**Subject: MHI's Response to NRC's Request for Additional Information No. 677-5325
Revision 2 (SRP 07.08)**

US-APWR Design Certification

RAI NO.: NO.677-5325 REVISION 2
SRP SECTION: 07.08 – DIVERSE INSTRUMENTATION AND CONTROL SYSTEMS
APPLICATION SECTION: TECHNICAL REPORT MUAP-07014
DATE OF RAI ISSUE: 1/10/2011

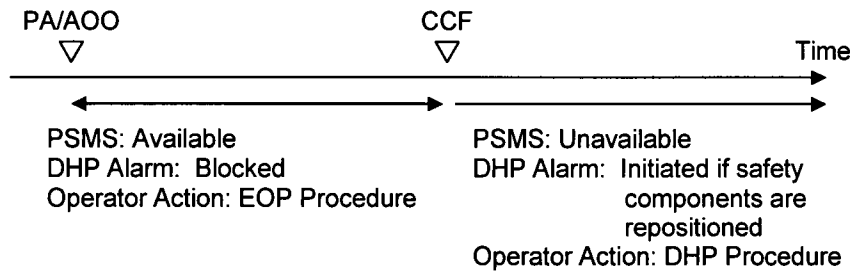
If the CCF occurs after the PA/AOO occurs how does this impact the availability of the prompting alarms?

Next consider the case where a CCF occurs after a PA/AOO is already in progress. Between "after the PA/AOO" and "before the CCF", the PSMS actuates automatic functions and blocks the DAS prompting alarms. These PSMS automatic actuations preclude the need for time critical manual actions. Based on the PSMS alarms and indications, the operators respond to the PA/AOO using the Emergency Operating Procedures (EOPs). During EOP execution, operators

will detect the CCF based on plant instrumentation and control anomalies. If the CCF results in repositioning plant safety components to their pre-actuated state, then the DAS prompting alarms will be generated. (See the following figure.)
